DART SERVICE INSTRUCTION

TO AMEND INSTALLATION INSTRUCTIONS D350-591 REV. E

REF. CANADIAN STC SH92-6 REF. FAA STC: SH967NE

D350-591-211 (ECF P/N 704A 41 640 008) D350-591-212 (ECF P/N 704A 41 640 007) HIGH GEAR STEP

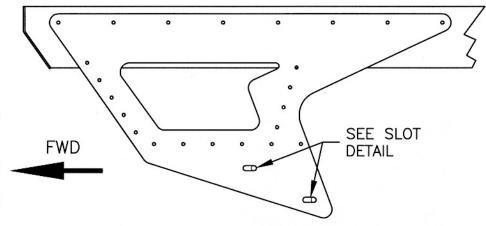
TO ALLOW FOR BETTER FIT ON SOME LANDING GEARS, IT IS ACCEPTABLE TO SLOT FRONT ATTACHMENT HOLES OF THE DART D350-591-211/-212 STEPS 0.551"x0.213" (14.0mm x 5.4 mm) AS SHOWN BELOW. TOUCH-UP PAINT FINISH PER ICA-D350-591 Rev. Ø AS REQUIRED.

DESIG	4	DRAWN BY	DART AEROSPACE LTD HAWKESBURY, ONTARIO, CANADA
CHEC	KED _/	APPROVED	DRAWING NO. REV. B
	A	9	DSI 9249 SHEET 1 OF 1
DATE			TITLE SCALE
03.02.27			STEP ATTACHMENT HOLES NTS
Α		03.02.13	NEW ISSUE
В		03.02.27	0.551" (14.0mm) WAS 0.410" (10.4mm)
